**ADDENDUM NO. 1**

**CID 01-STILLHOUSE BRANCH WASTEWATER TREATMENT FACILITY  
IMPROVEMENTS**

**PROJECT NO.: 2-01590 | TWDB CWSRF NO. 73776**

**DATE OF ADDENDUM: MAY 24, 2023**

**A1** 30" SO2 MH TO CHLORINE PIPE (LINE "G")  
H:1"=10'  
V:1"=1'

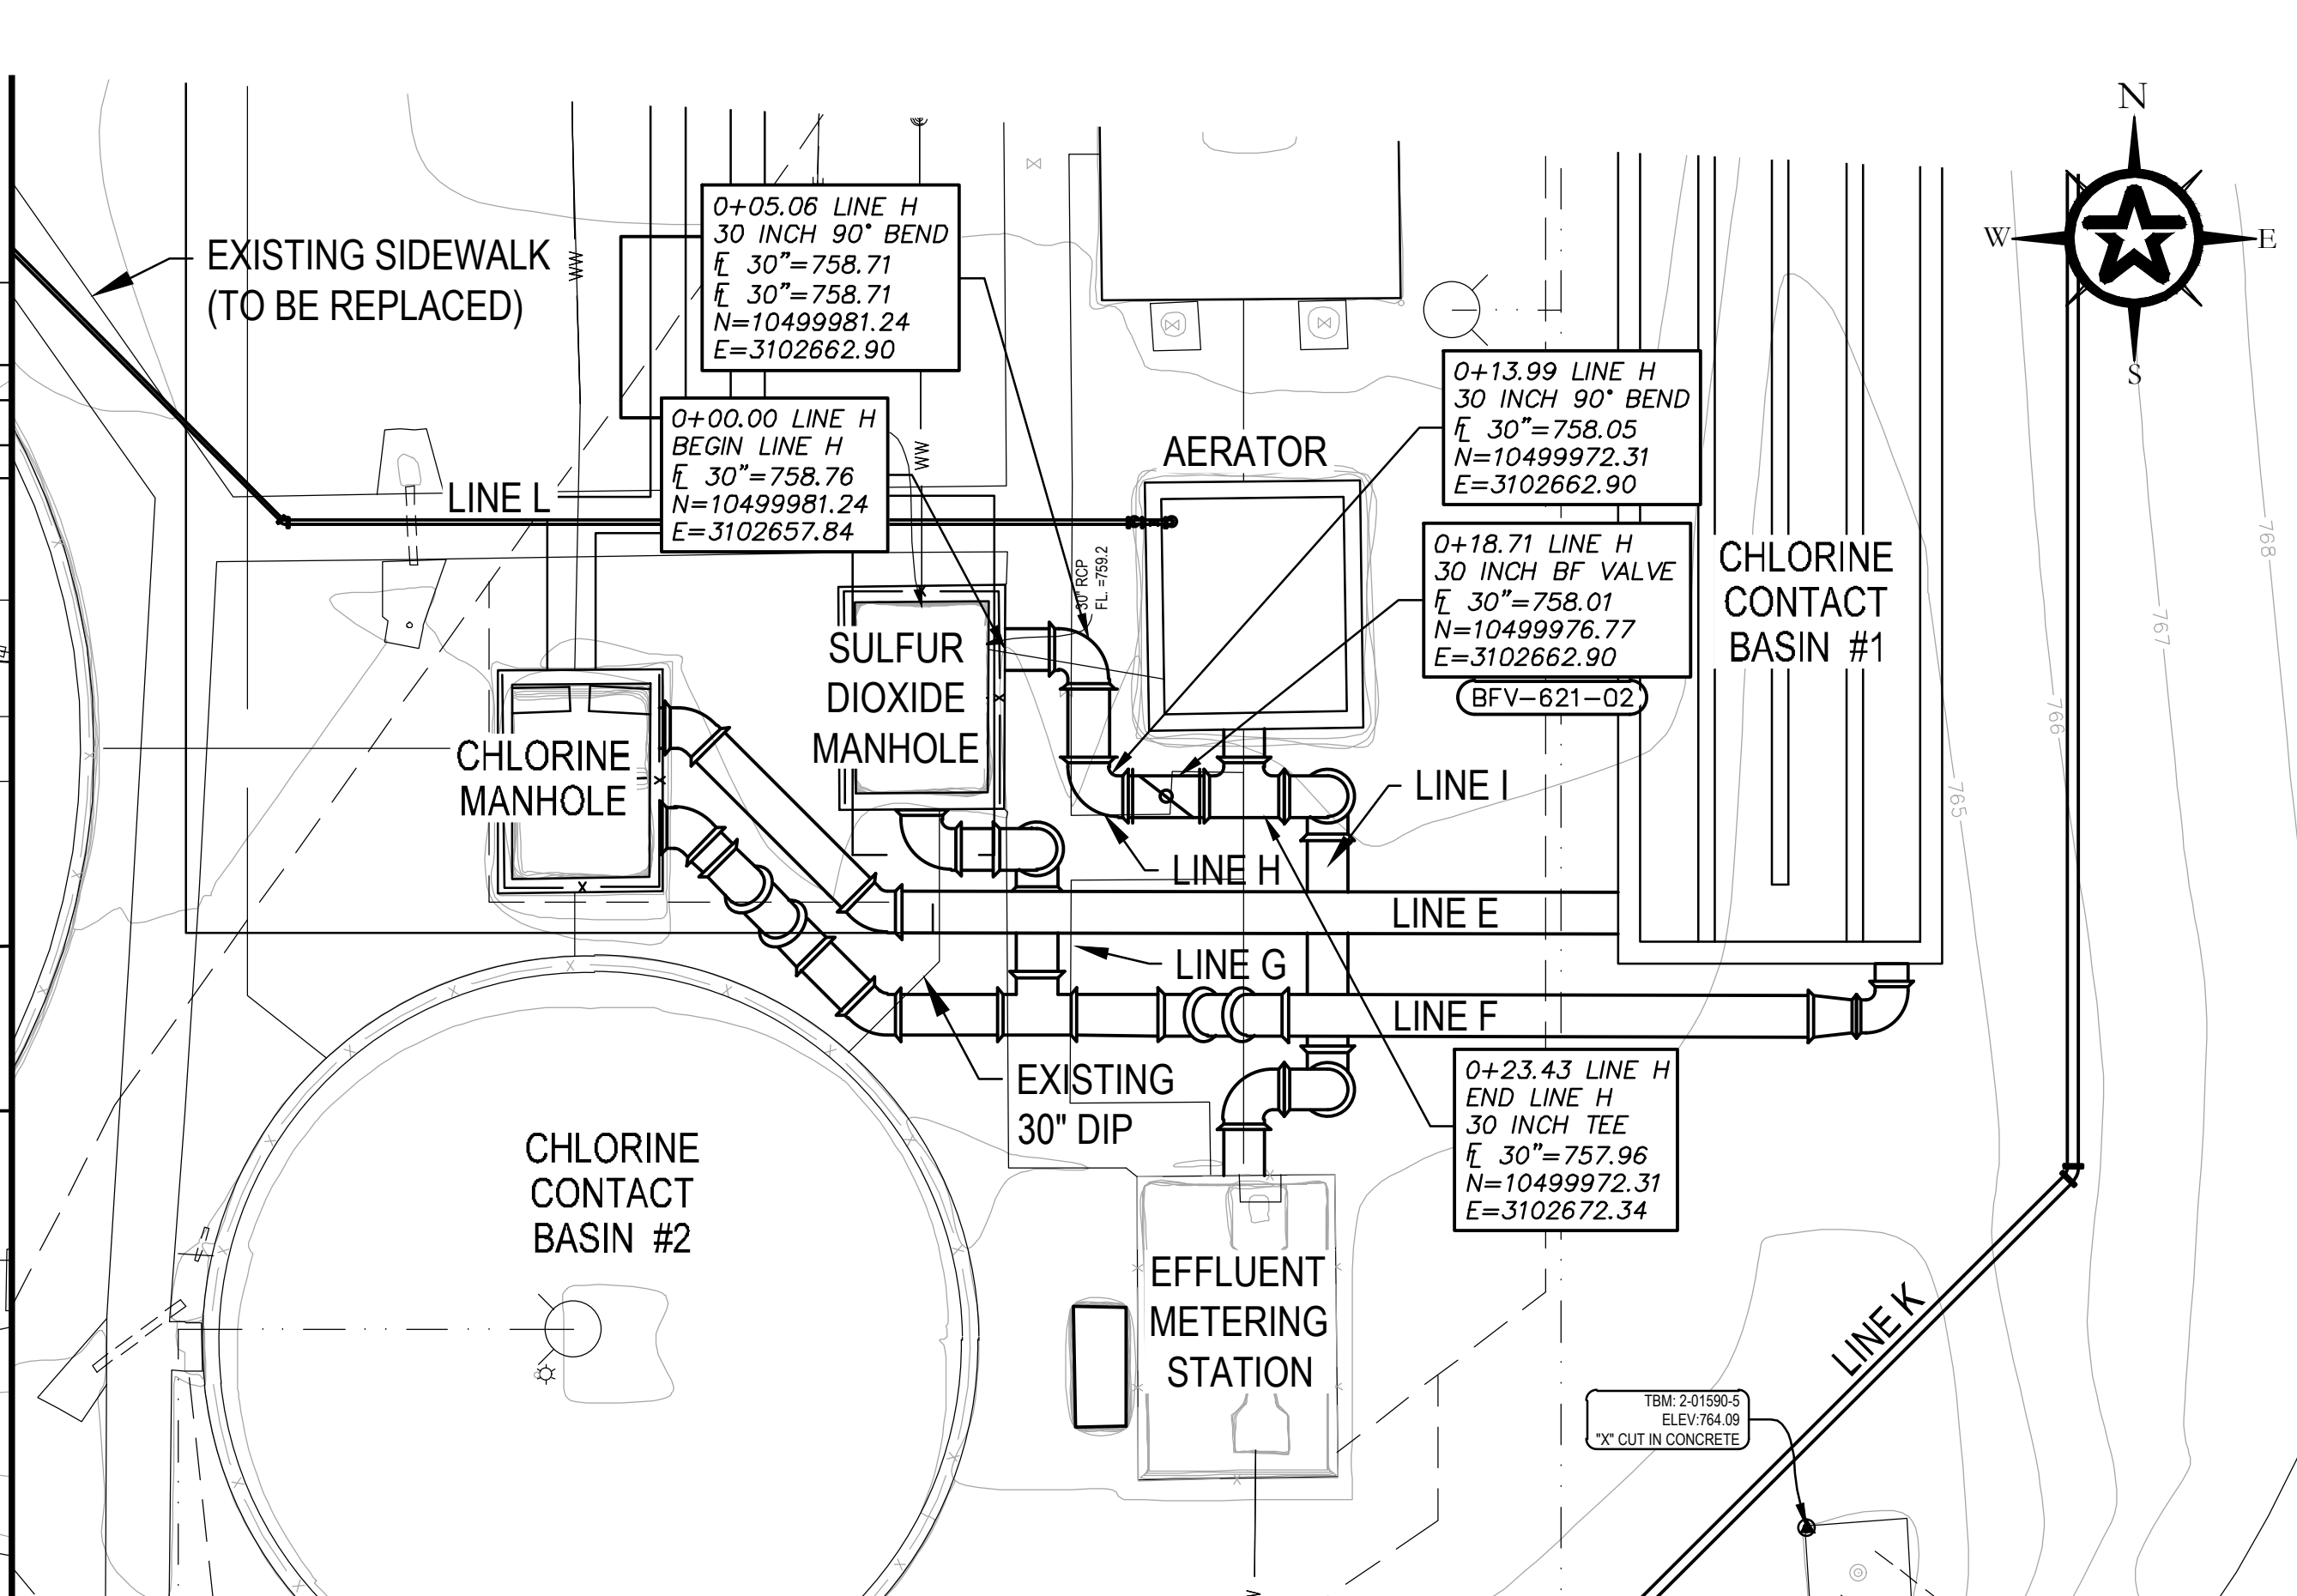
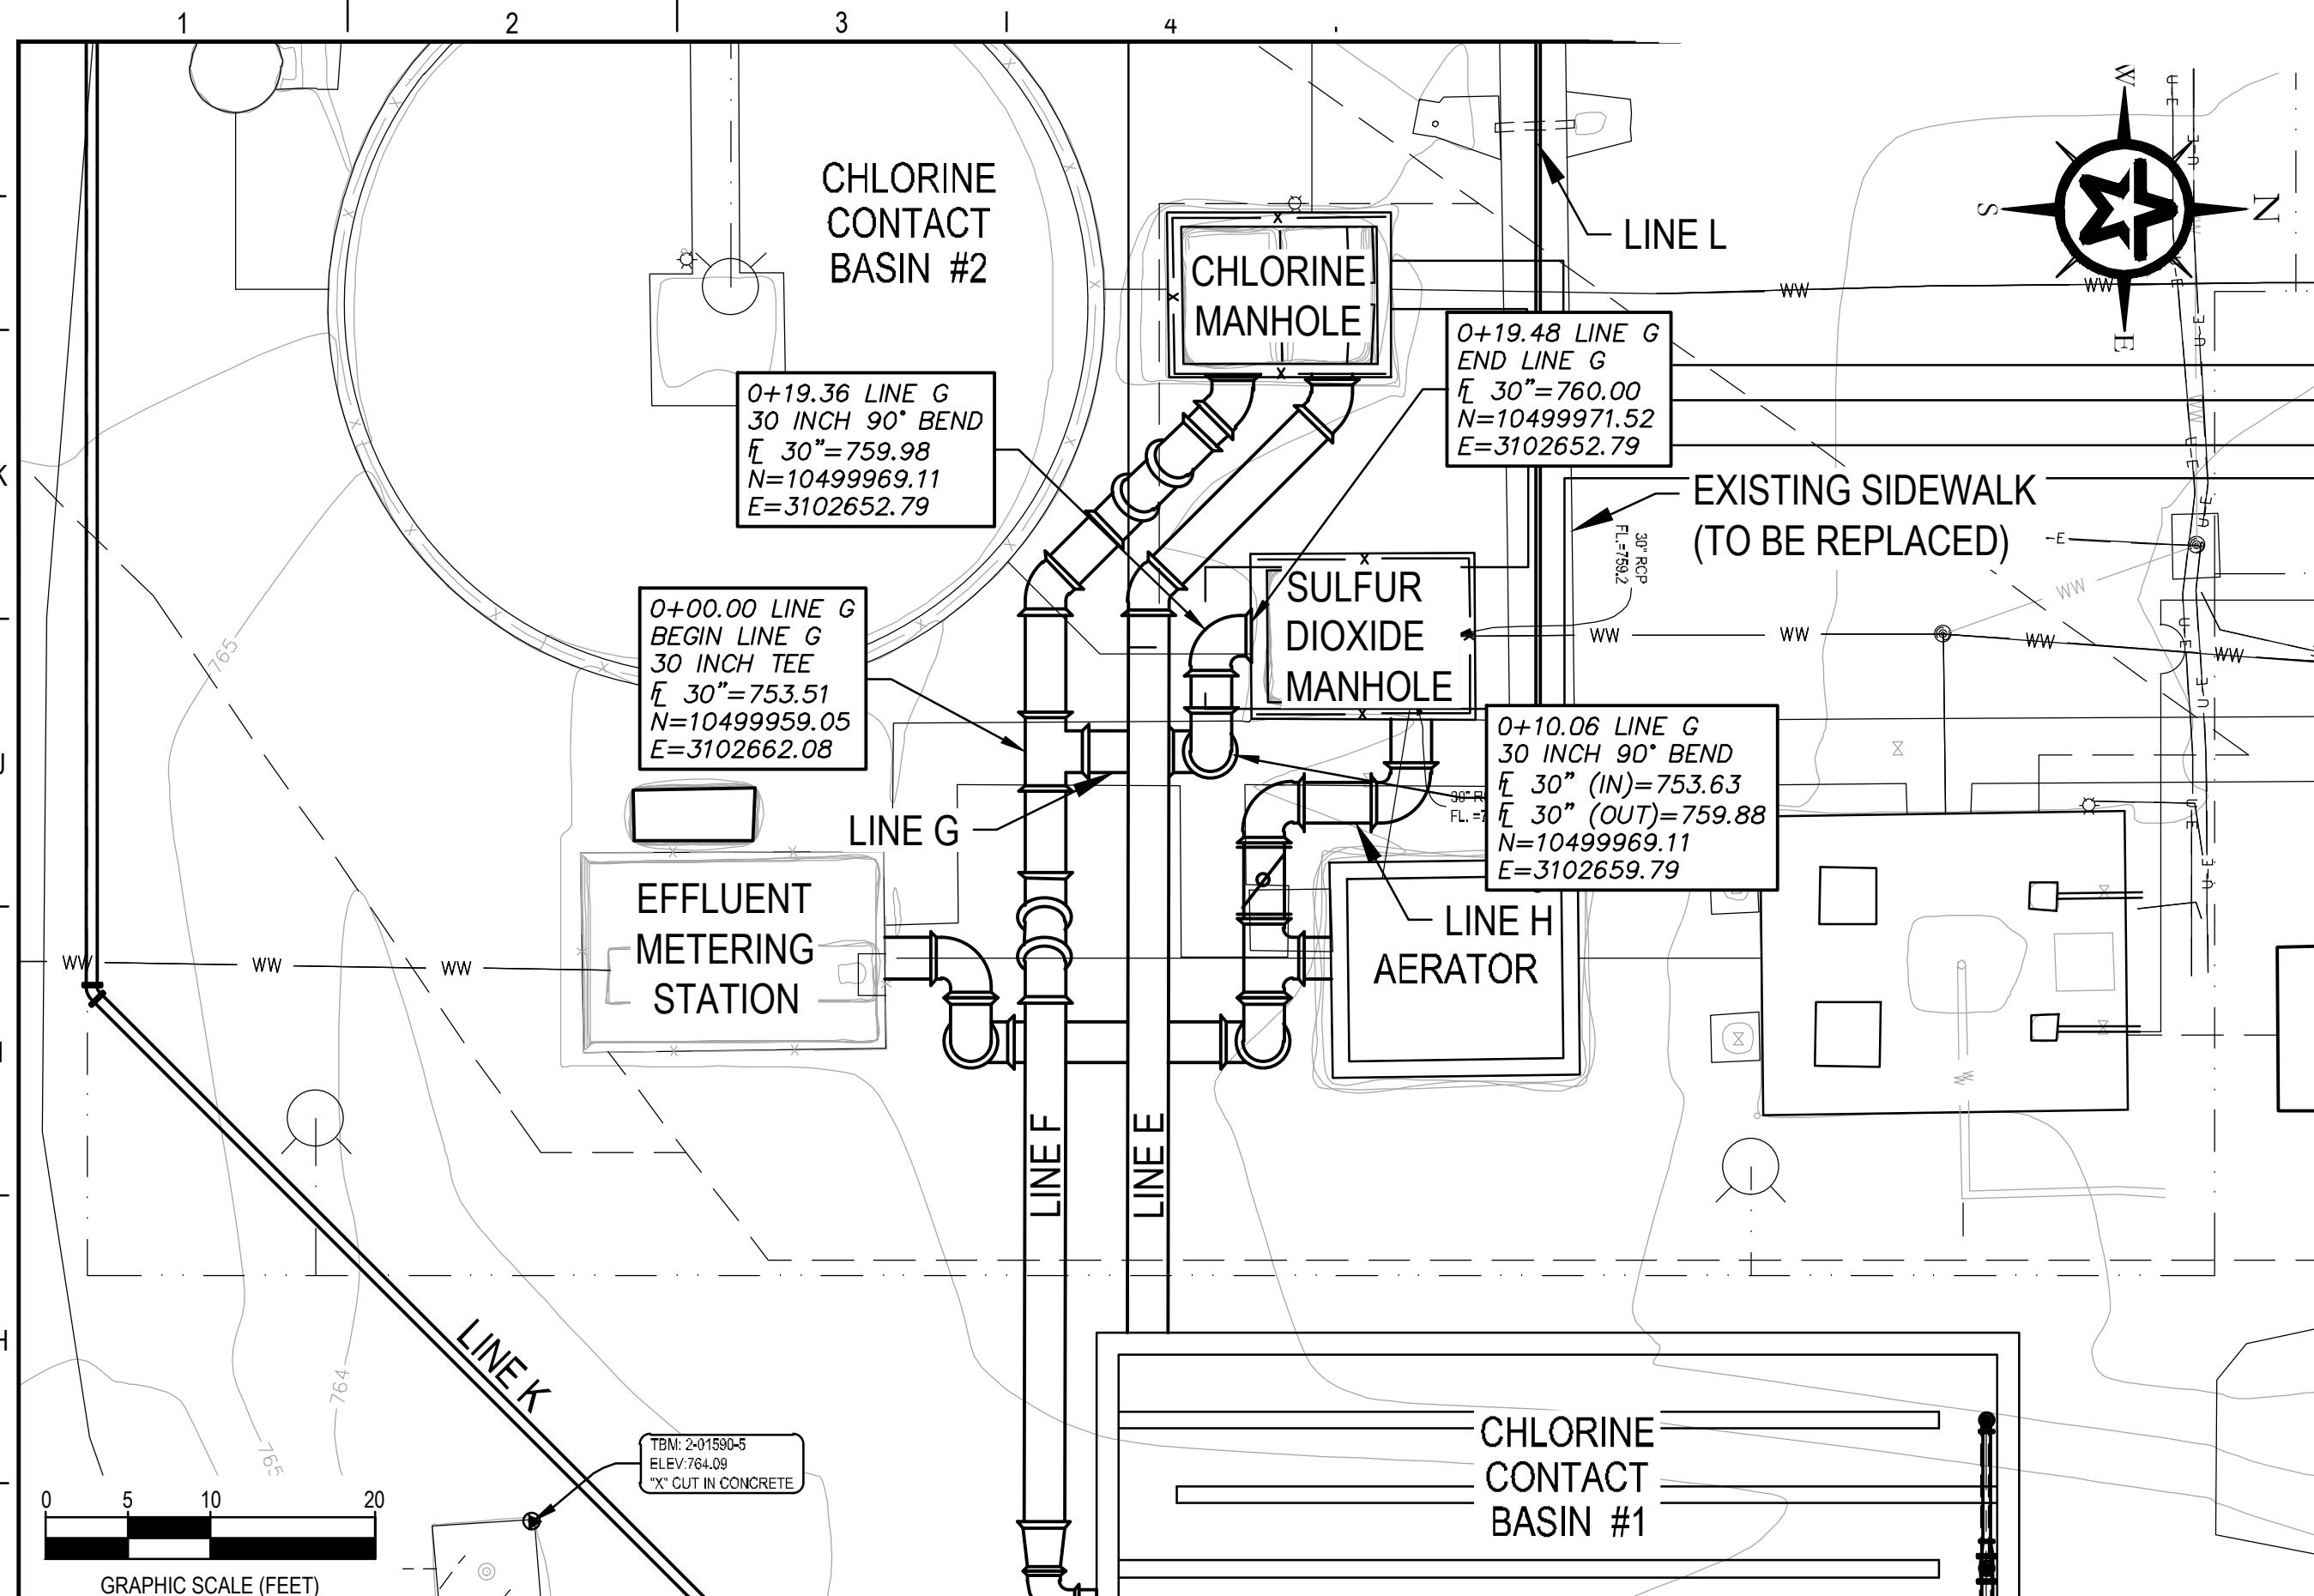
a. Sheets C-08 through C-17

REVISE yard piping to reflect the pipe labels on Sheet M-01 and Sheet M-02.
